project title		KOKO + Hope & Anchor + Bayham Place Camden, London	
drawing title	scale	date	
Proposed Roof Plan	1:100 (A1)	26.05.17	
drawing number	drawn	checked	
AHA/KC/GA/105	FR/PCI	DA	
	revision		
	F

Legend for works under Retrospective application

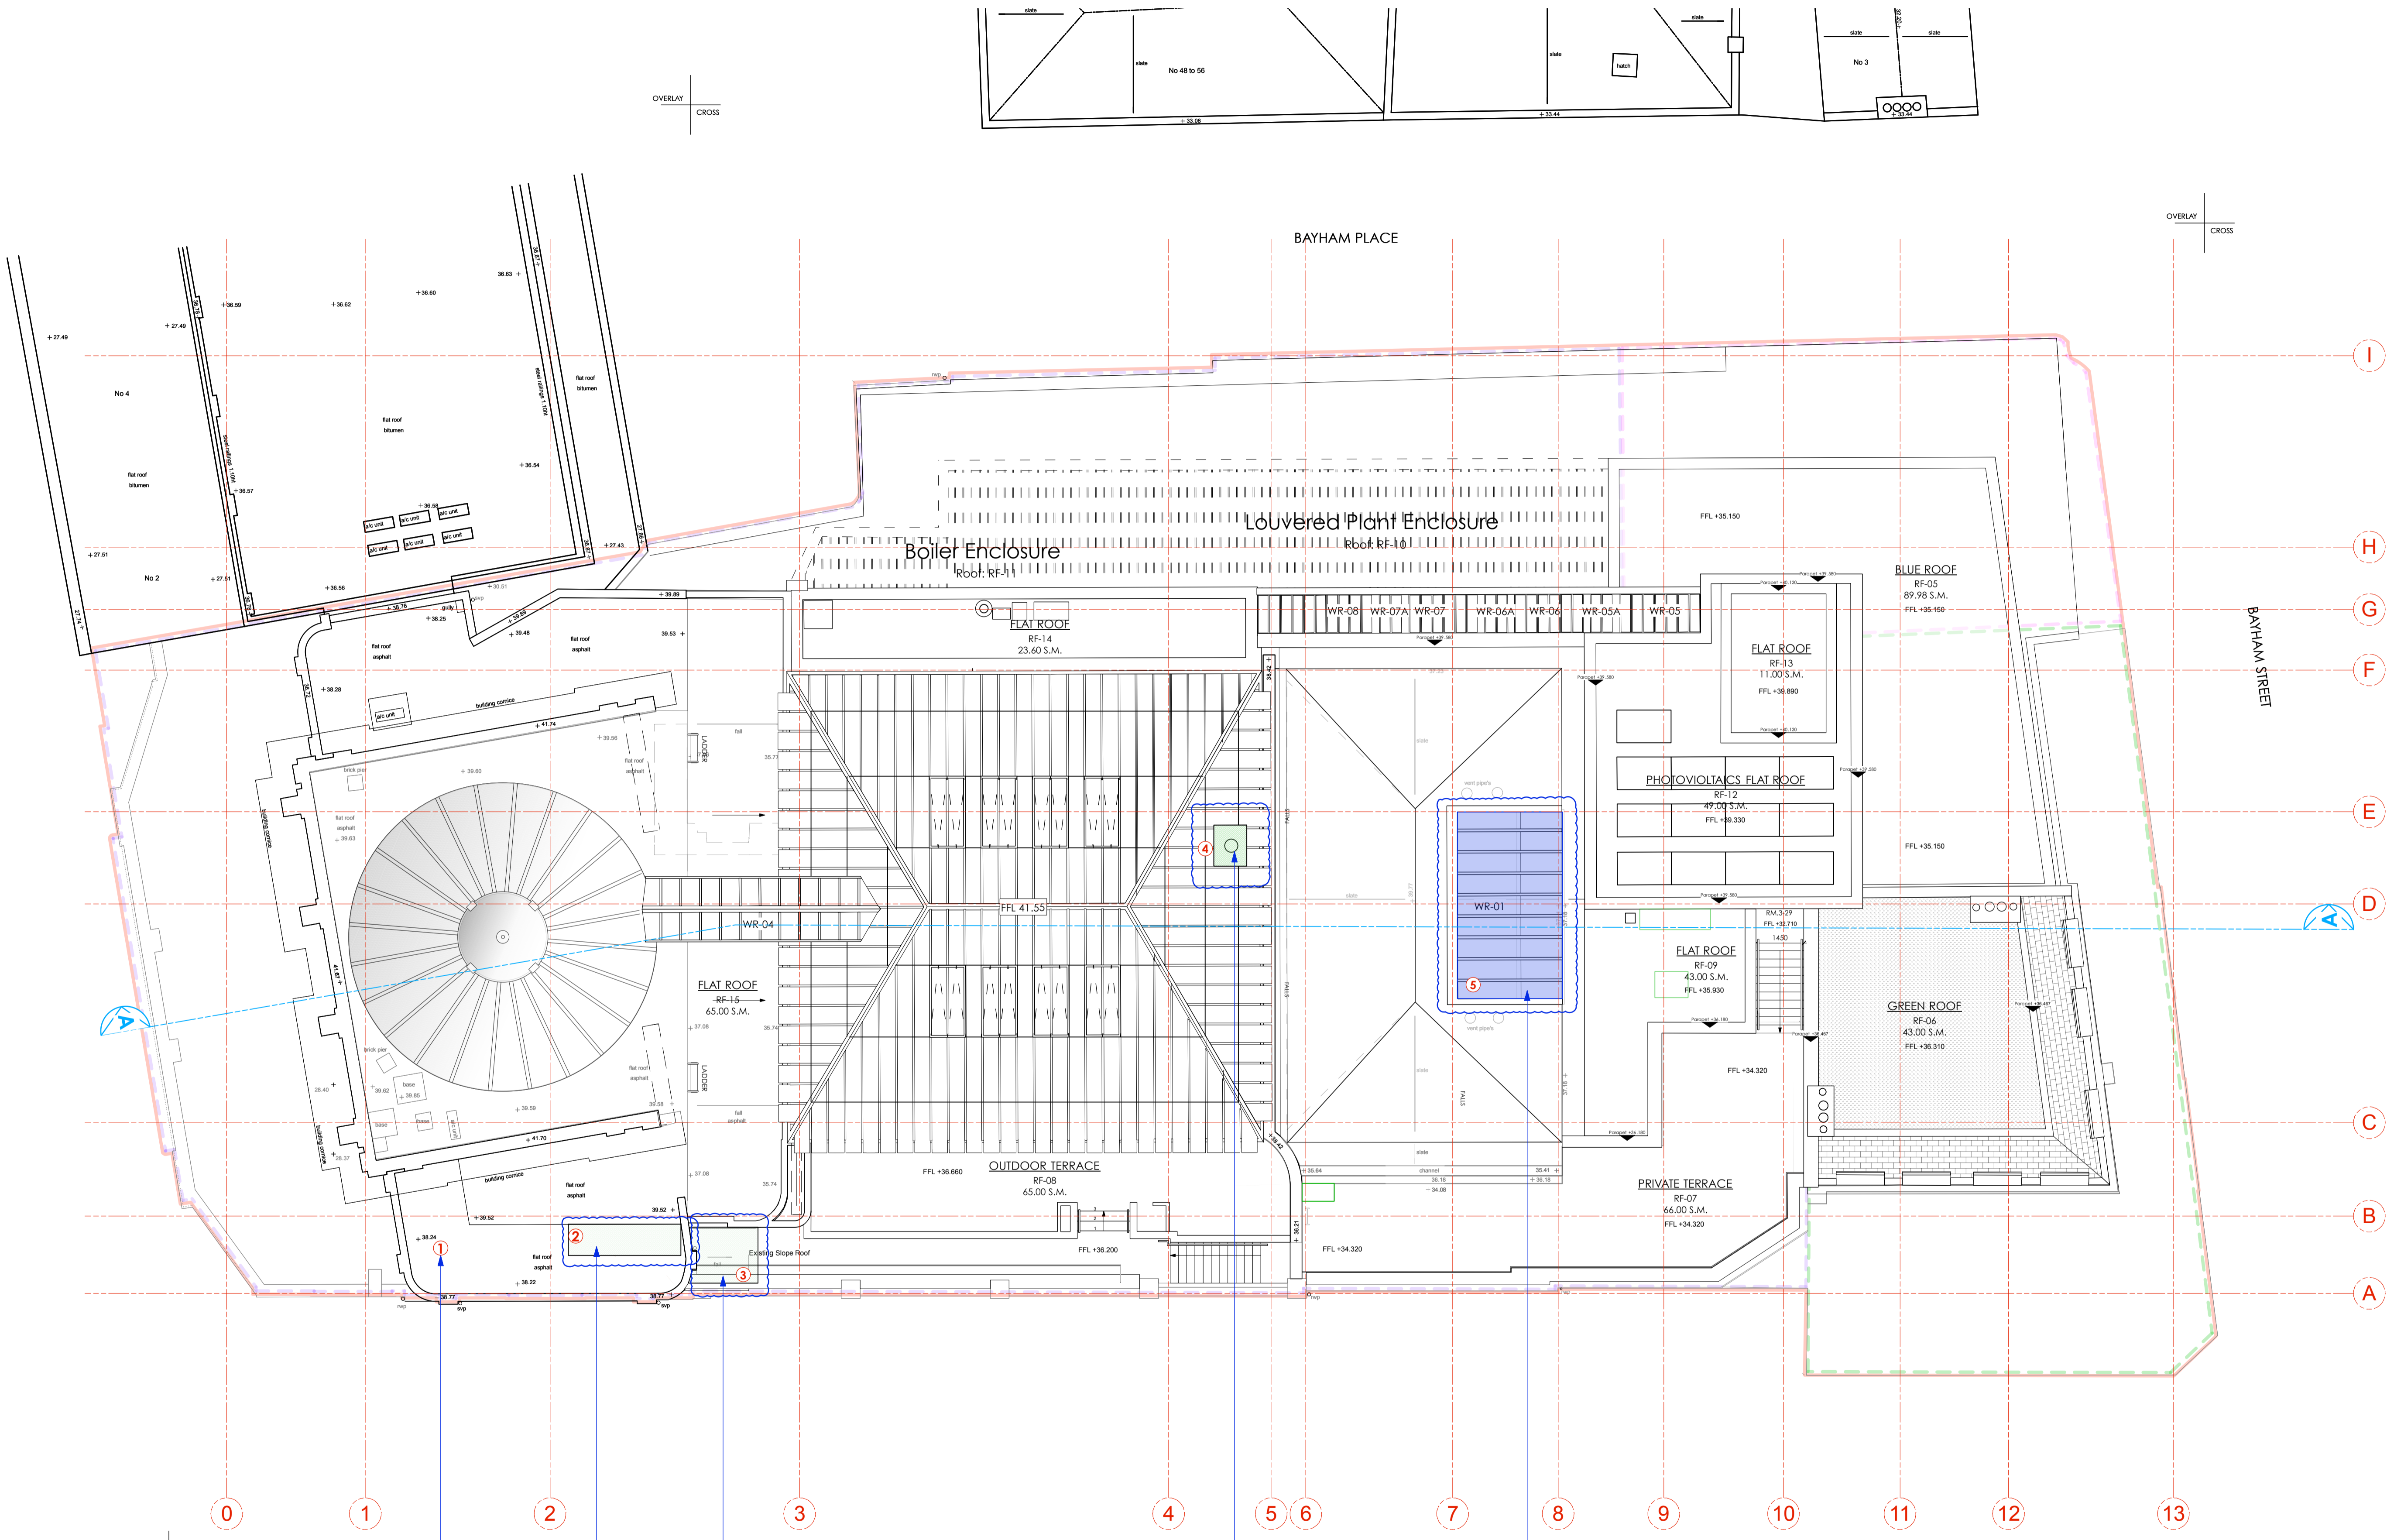
revision / date / amendments	
- / 26/01/18 /	- First Issue
A / 02/02/18 /	- Indicative glazing bars and tiers shown on Sky lobby roof.
B / 01/03/18 /	- Roof window numbers updated
C / 01/08/18 /	4.8. Wall extended to rear of WC's by 1.5 bricks 4.9. Wall depth increased to include void for services 5.3. Existing chimney to rise above parapet 5.4. Chimney added from Pavilion
D / 15/08/18 /	Colour coding added to revised drawing RevC
E / 03/08/19 /	Proposed Dome LBC Application for 1. Permanent Dome Truss. 2. Dome Front Pier PFCs. 3. Replacement of Dome Copper Roof 3. Removal of Decorative Dome Ladder
F / 11/02/2020	Retrospective planning application for: 1. Removal and reinstatement at high level H/L 2. Removal and reinstatement at low level L/L 3. Removal and reinstatement of walls 4. Removal of walls. 5. Change to consented proposal. Refer to colour coded legend and annotations 1-5.

1. PV cells omitted from this location as PV cells above core will provide required power/output.
 2. Consented proposed fire escape staircase and door omitted.
 3. Area of existing sloped roof to be retained (not to be demolished) and door way omitted.
 4. Relocated chimney flue
 5. Existing rooflight glazing to be replaced to meet building regulations.
